Project: Public Works Building Transit Addition

PLUMBING - GRADE LEVEL DOMESTIC PLAN

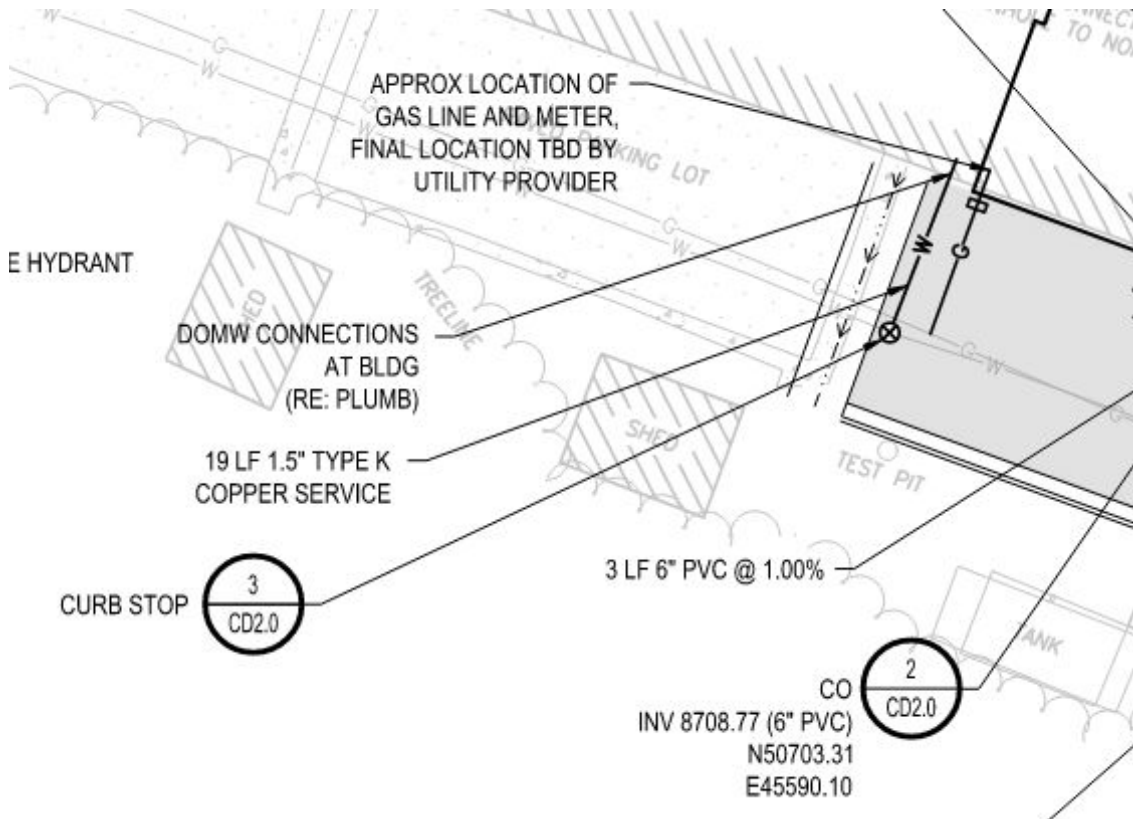
1. The Civil Utility Plan on C2.0 appears to show one 1-1/2" domestic water line routed to the building. The plumbing drawings show a 4" fire water entry and a 1-1/2" domestic water entry. Please clarify whether one water service is to be brought to the building and split, or if two separate water services are required.
